## Threshold Offset Contributions INPUT STAGE TO TRACK DISCRIMINATOR

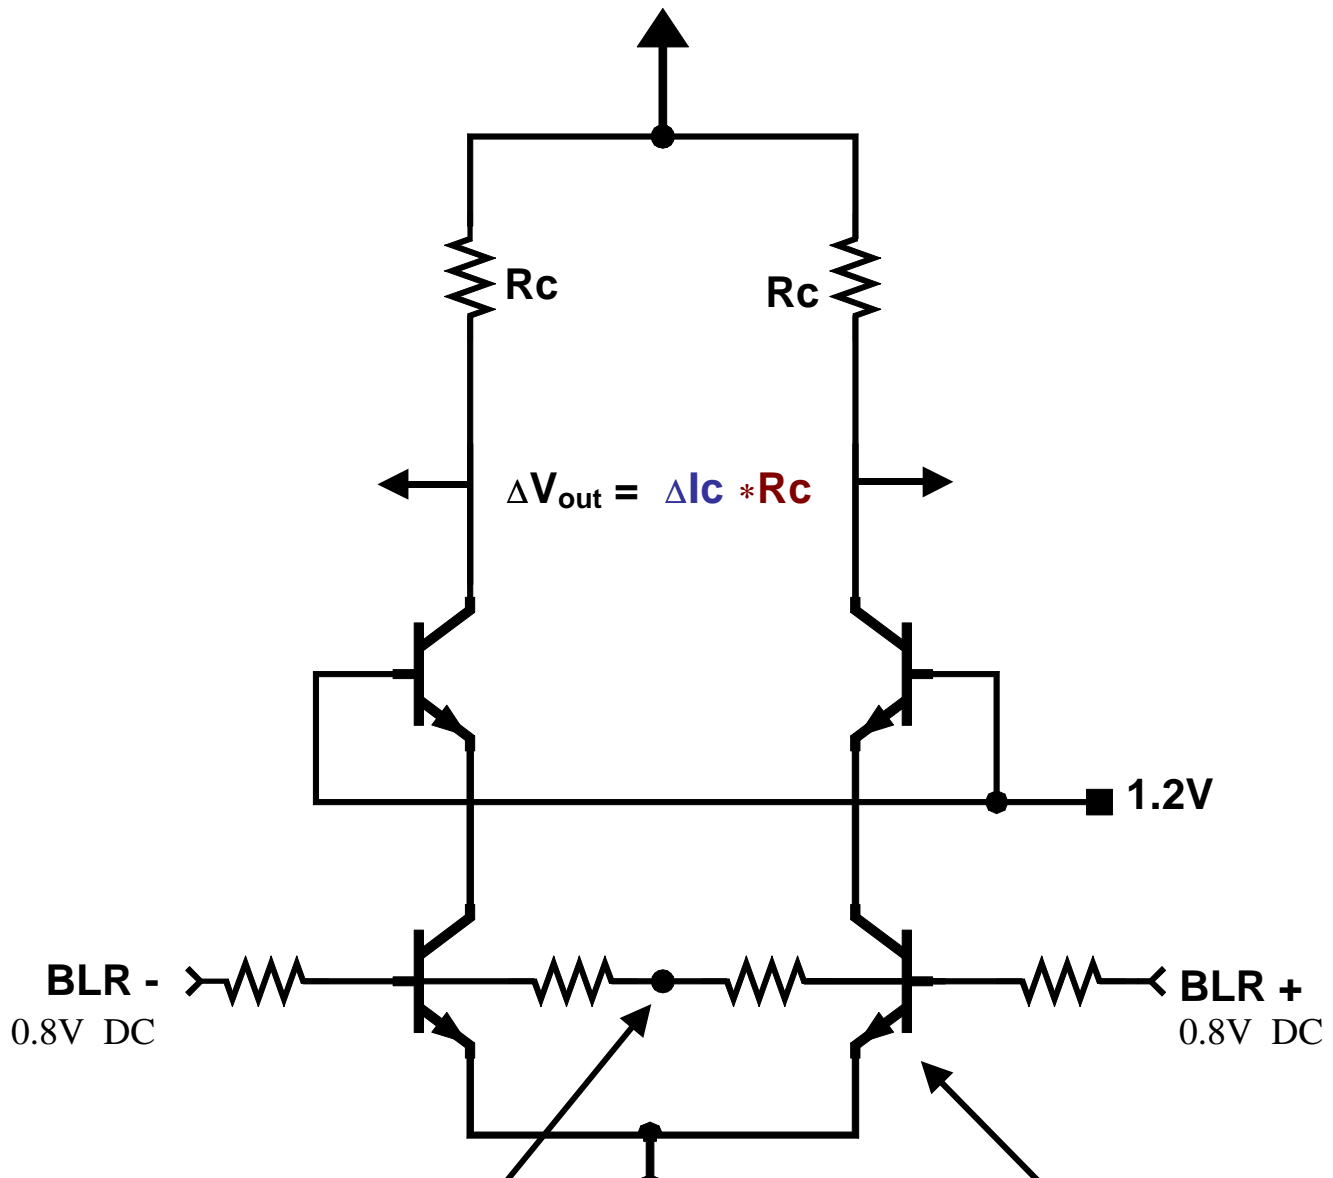
Connected to GND in ASDBLR99  
DC current through unpredictable resistor  
mismatch contributes threshold uncertainty.  
Process mismatch was larger than expected

Larger than Expected  $\Delta V_{be}$   
mismatch increased threshold  
Uncertainty.

Removed GND reference in Rev 00.
